Addendum 2

Project Stadium New Press Box – Marlin ISD
Issued December 8, 2023 by CEI Engineering Associates, Inc.
Proposal Opening December 14th at 2:00 PM

ADDENDUM NO. 2

PROJECT: Marlin ISD - Pressbox
HKS Project No. 26095.000

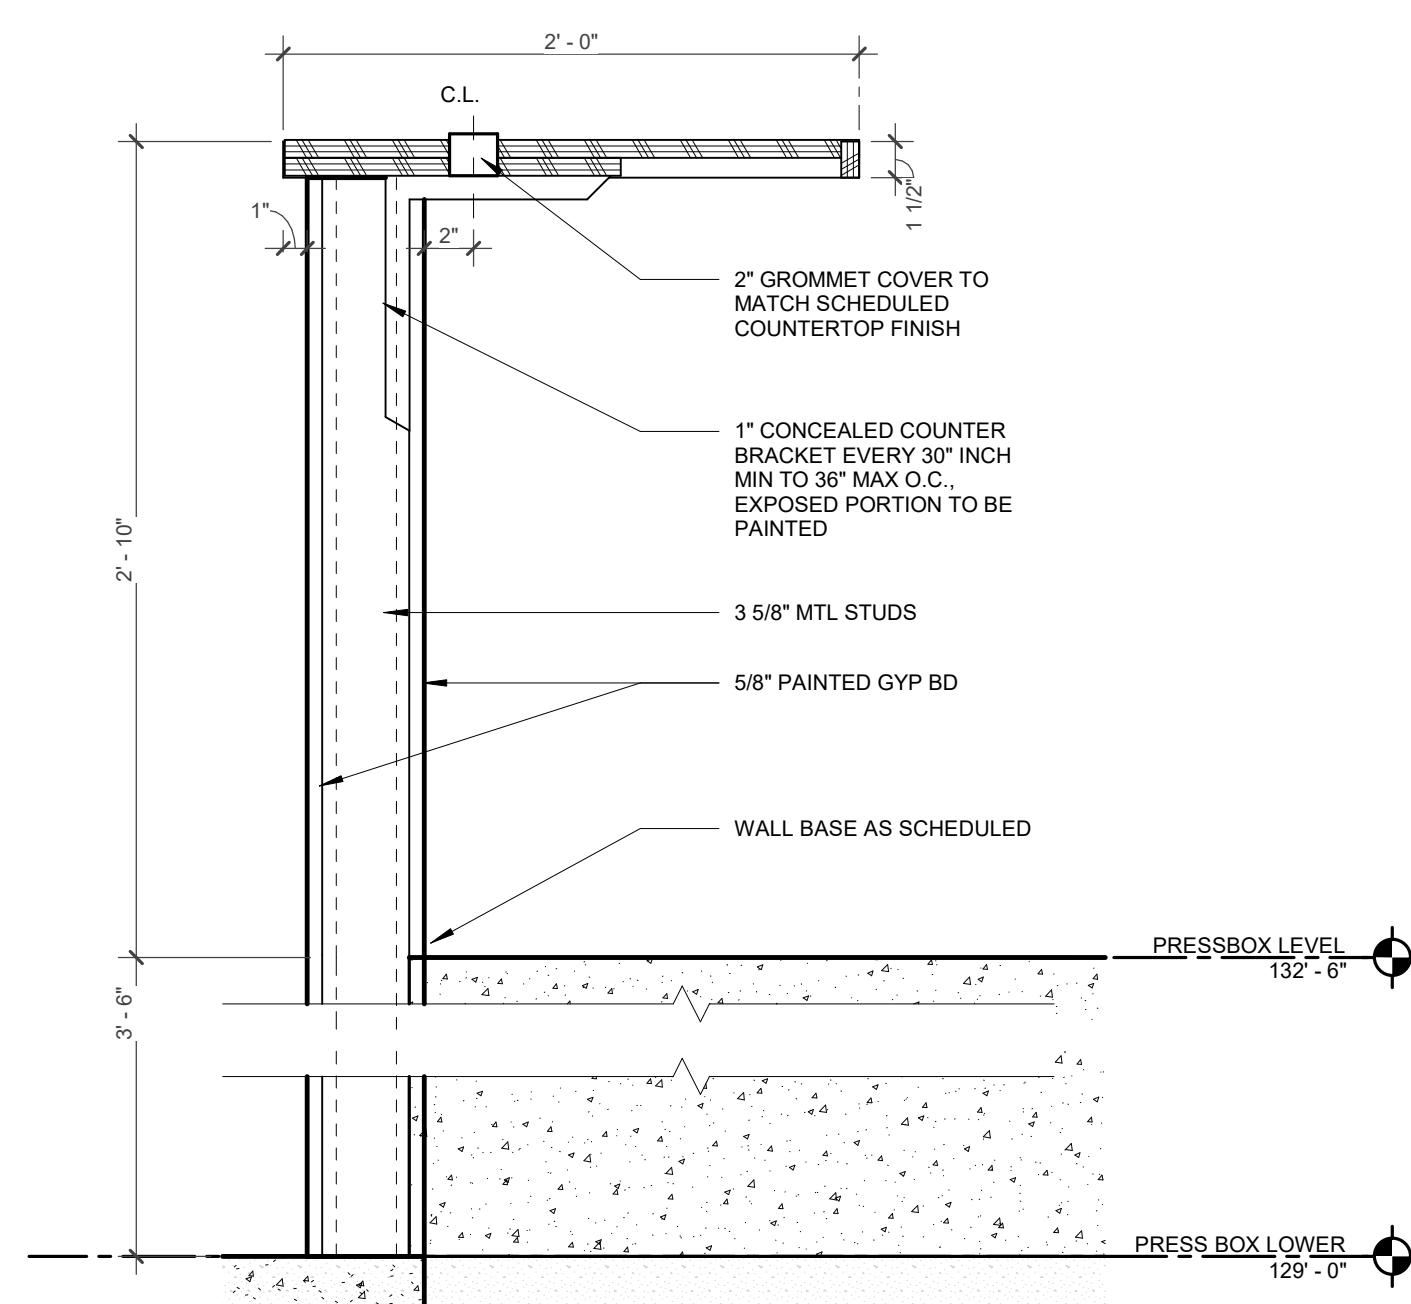
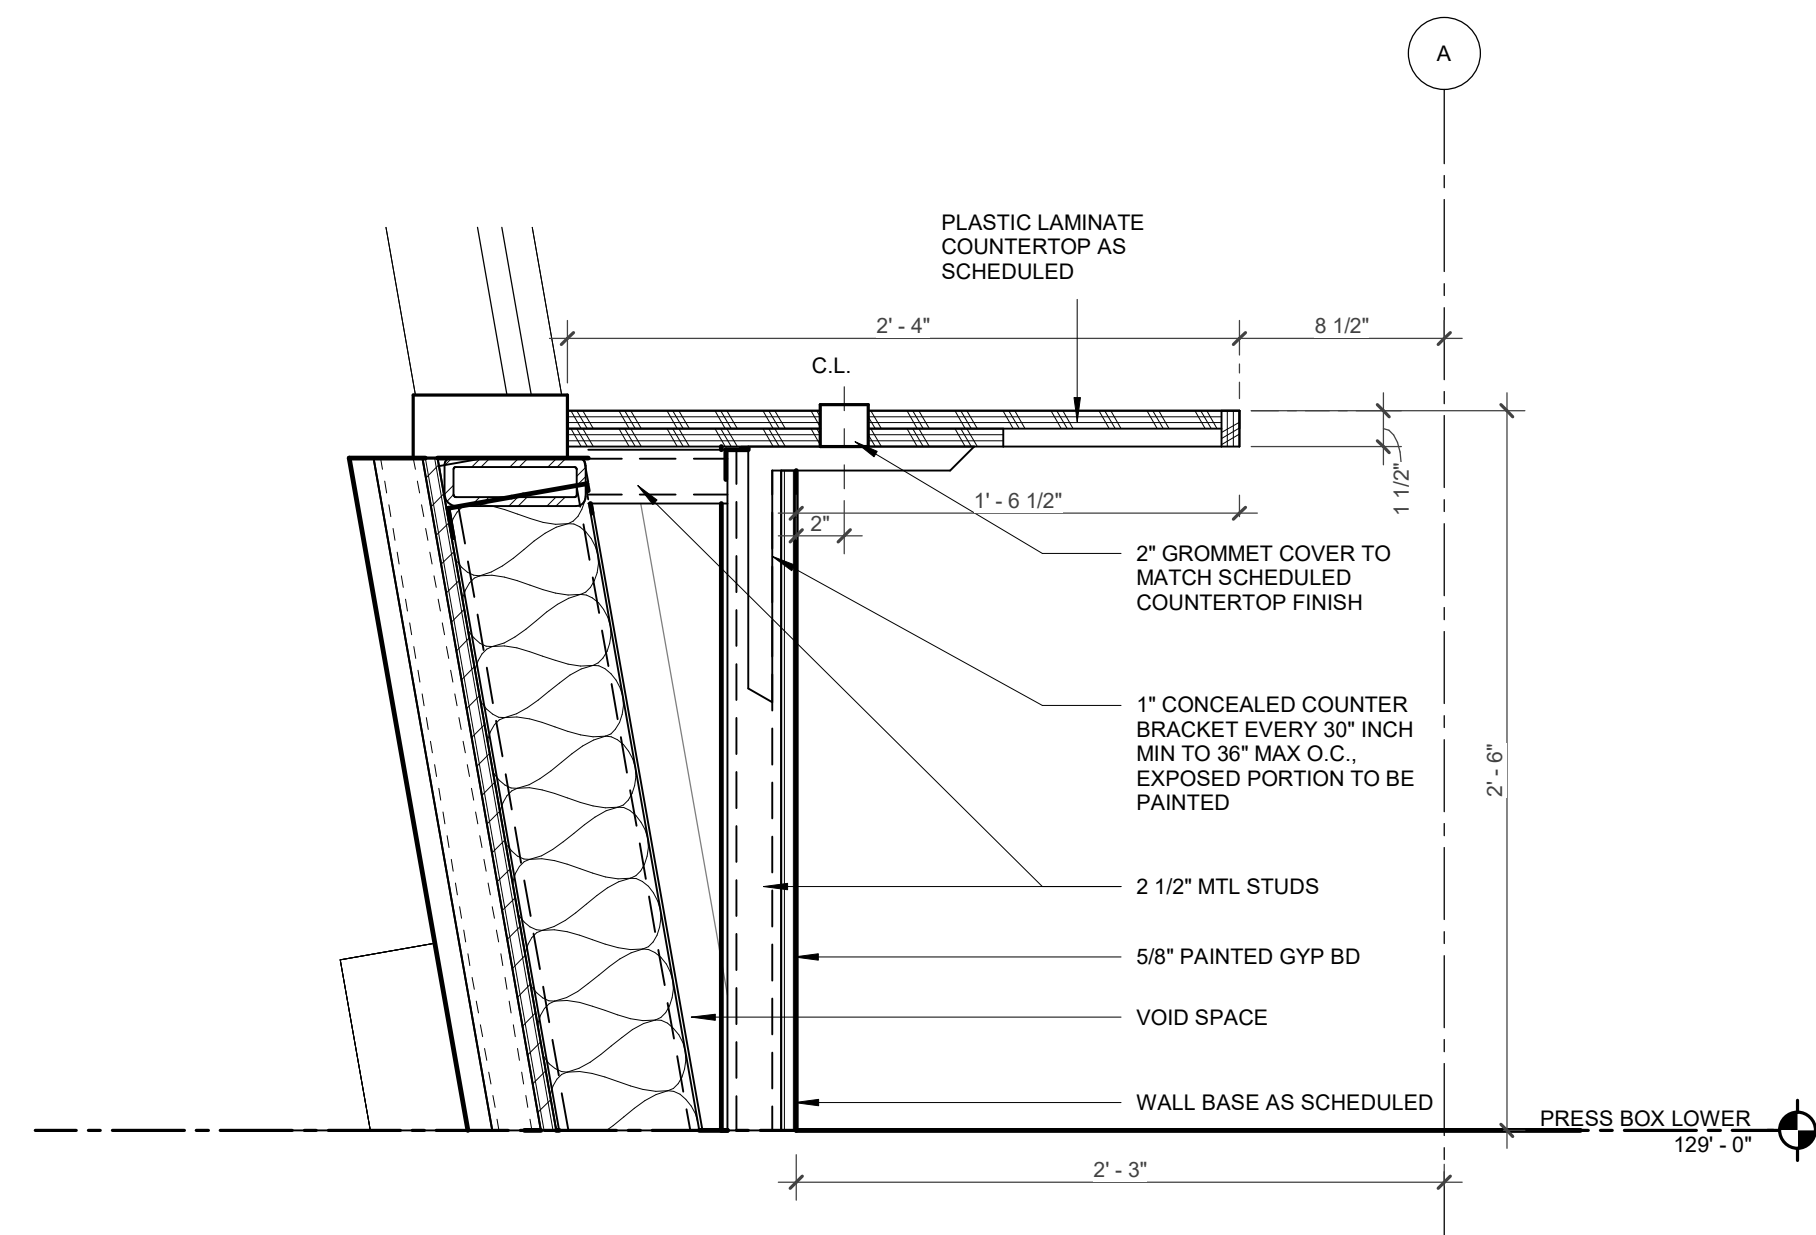
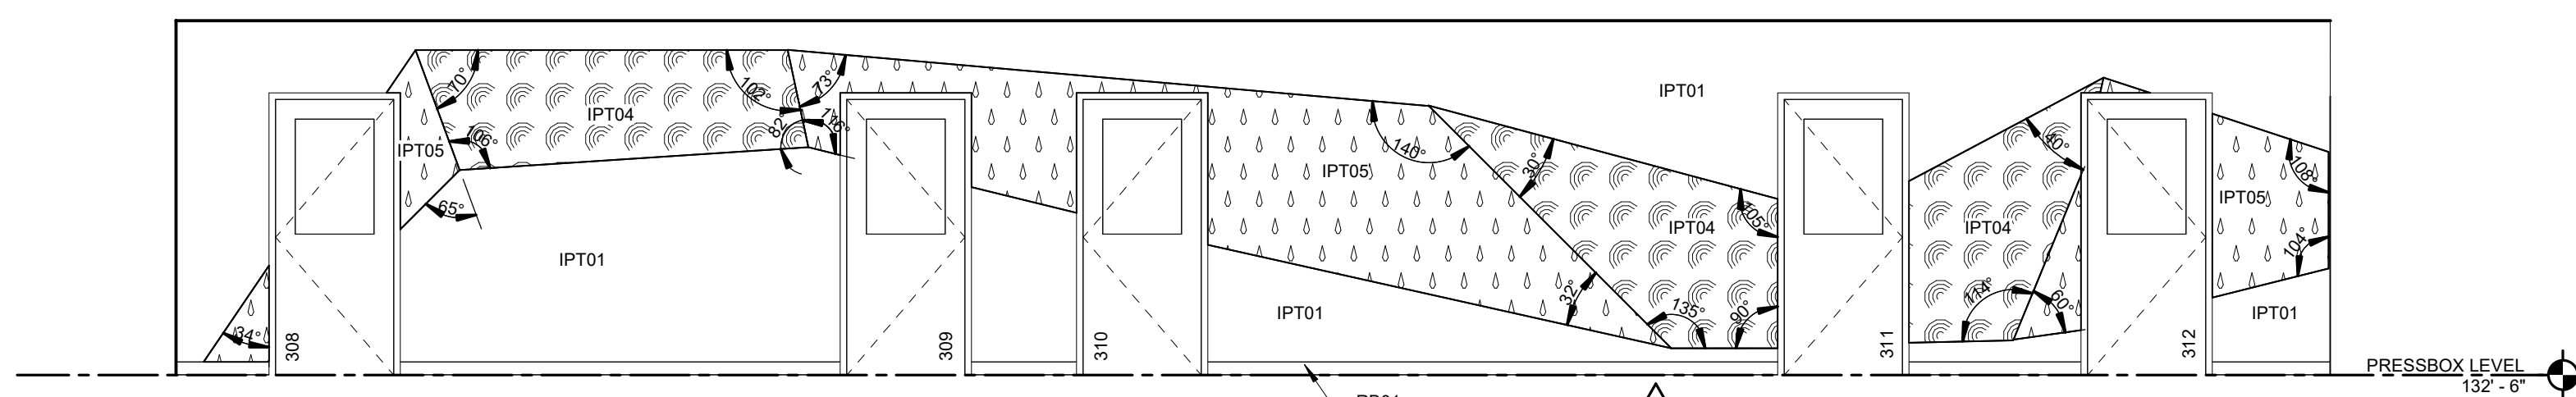
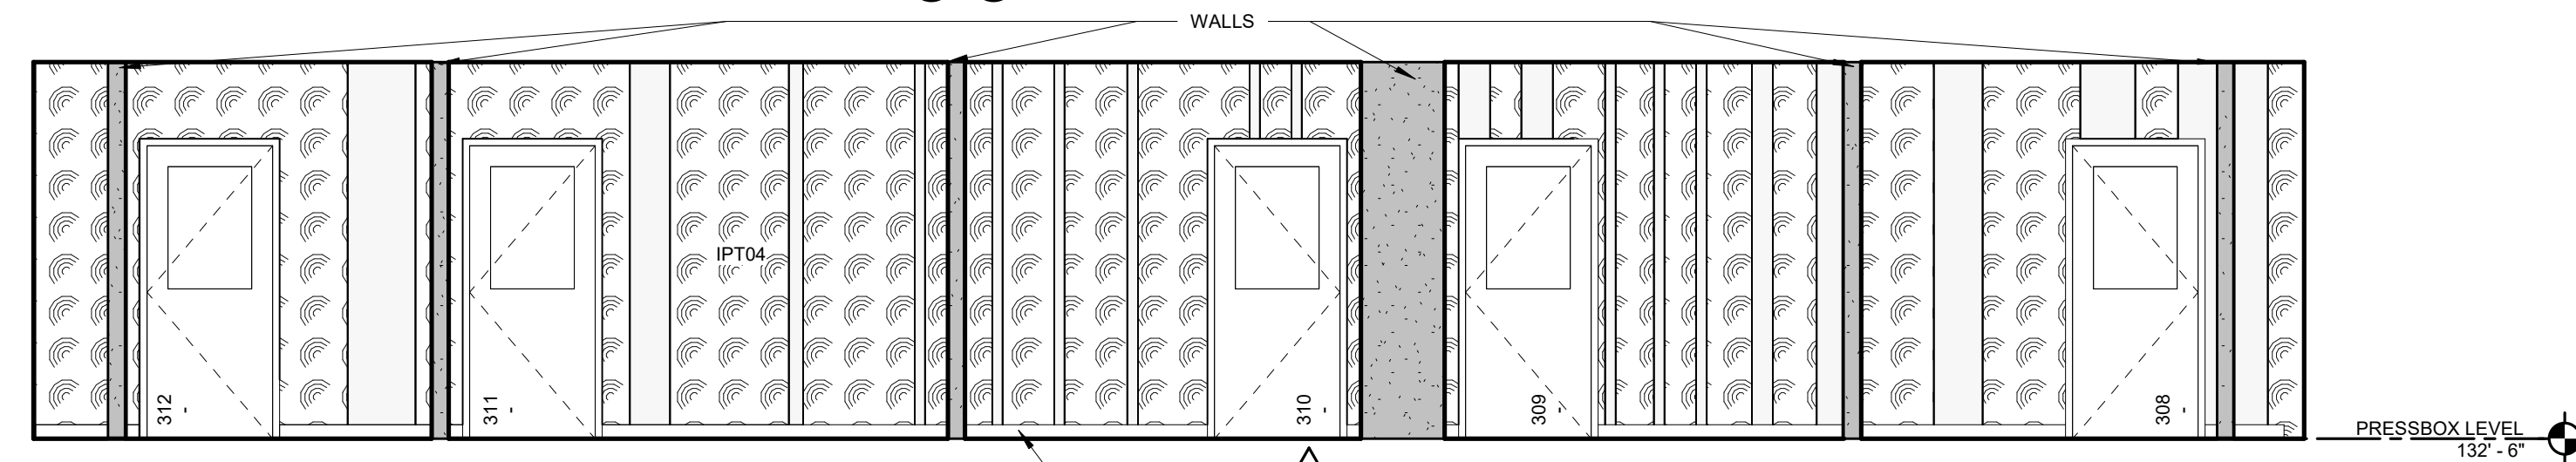
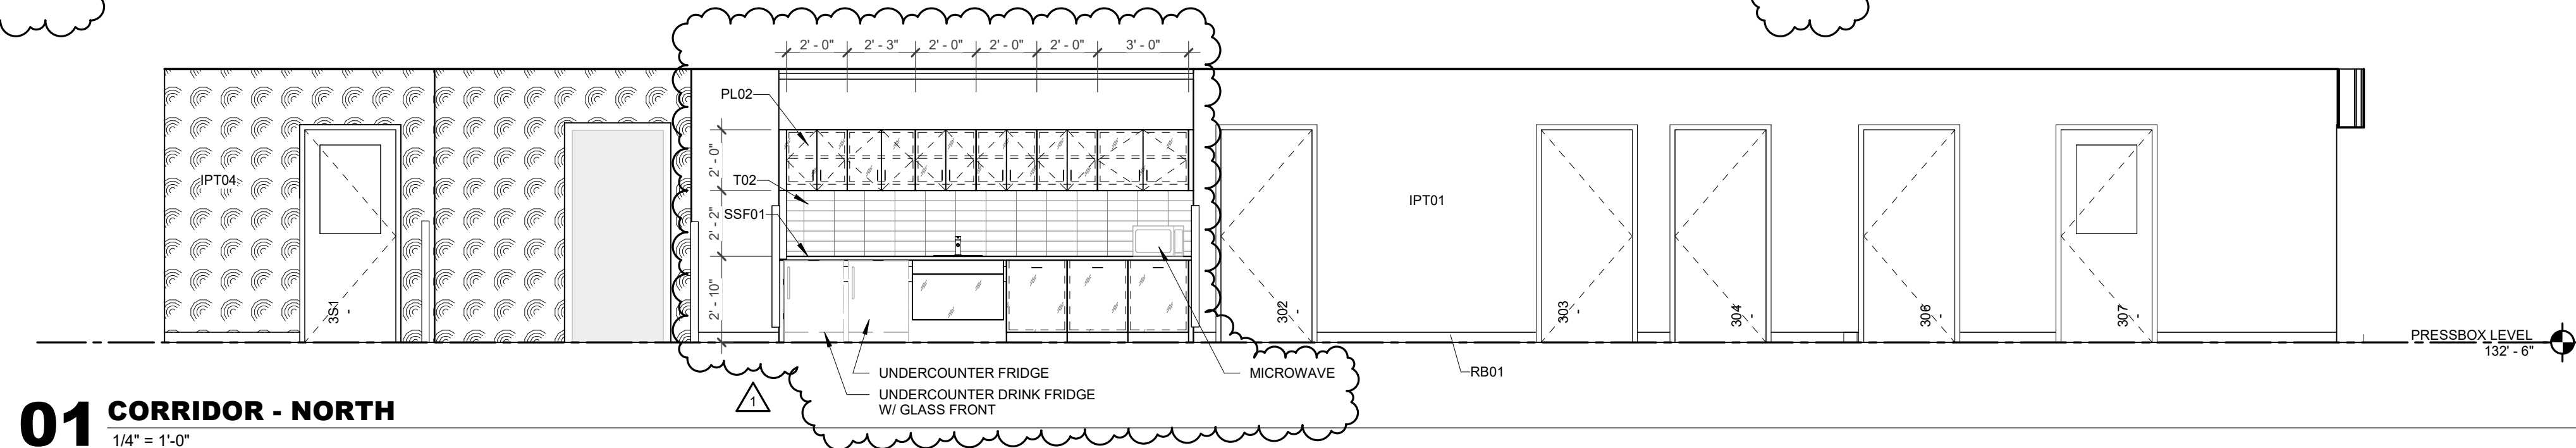
- Added elevation views 04 and 05
- **A3.51 – INTERIOR ELEVATIONS AND DETAILS**
 - Added additional cabinets and undercounter drink fridge to kitchen
 - Added wall graphics to Elevations 03 and 04

- Adjusted Detail 05
- **A4.00 – REFLECTED CEILING PLAN**
 - Added RCP for the ground level
 - Added ceiling and lights for elevator lobby
 - Adjusted ceilings and lights at Pressbox Level to match floor plan changes
